June 7, 2024

Ref: 52978.00

Re: Response to Request for More Information – Standard Dredge and Fill Wetlands Permit Application
X178-1 Transmission Line Rebuild Project – Campton, Thornton, Woodstock, NH

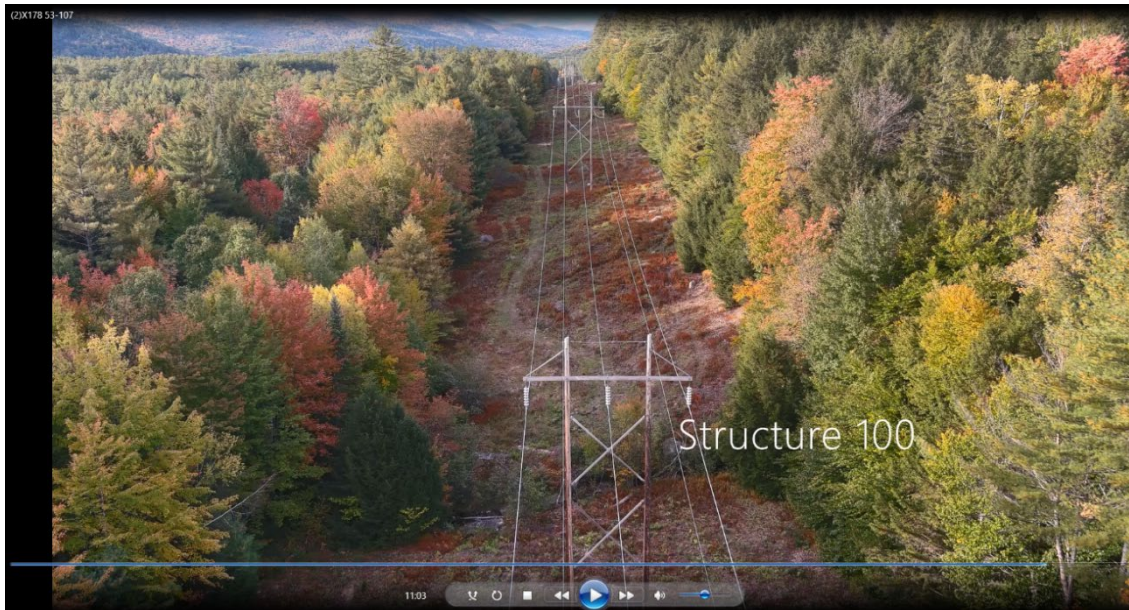
c. Plan Sheet 13. Can the proposed access road be shifted easterly to reduce impacts to W-64?

Response: Unfortunately, this change cannot be accommodated due to the steep slopes, boulder-strewn surface and bedrock outcropping that is present within the eastern portions of the ROW near W-64 and Existing Structure 84. Due to the difficult terrain, the structure must be accessed from the higher elevation flatter terrain in the western side of the ROW as shown on the plans and Photo 1, below. The steep terrain and bedrock outcroppings extend within the ROW to the north, east and south of the structure and cannot accommodate an access road without a significant amount of earthwork. See Photo 2, below. In addition, the location of the road within the ROW shown on the plans is the location of the existing access road which was used previously.
